Product Change Notification

PCN NUMBER : PCN085
Product Category : DIP & SIP Switches – Design Change
Issue Date : 31-May-2019
Effective Date : 31-May-2019
Reason for change : To improve the production efficiency & product quality.
Change to laser-printing of legend to meet low-halogen requirement.
Description of change : Thermos-printing 1P~3P don't have enough space to print DIP Logo. Laser printing 1P~3P can print DIP logo and 1P~2P change printing position of Date Code as shown in below diagram.
Change to Form Fit Function : There will be no change in Form Fit and Function
Parts Affected :

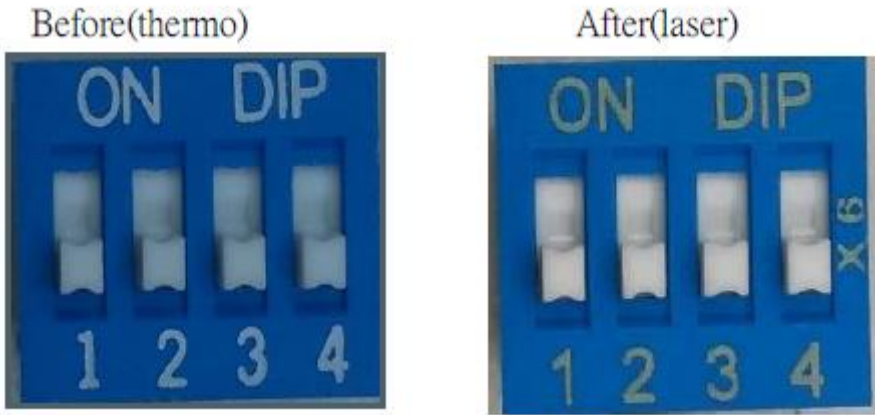
NDA 1~3P before(thermos-printing)	NDA 1~3P after(laser-printing)
	<div data-bbox="922 1496 1222 1653" style="border: 1px solid black; padding: 5px; margin-top: 10px;"> <p>1P/2P/3P comparison</p> <ol style="list-style-type: none"> Add DIP logo Add Date Code in font of product </div>

NDA 4~12P before(thermos-printing)	NDA 4~12P after(laser-printing)
	<div data-bbox="1023 936 1339 1072" style="border: 1px solid black; padding: 5px; margin-top: 10px;"> <p>4~12P comparison 1. Add Date Code in font of product</p> </div>
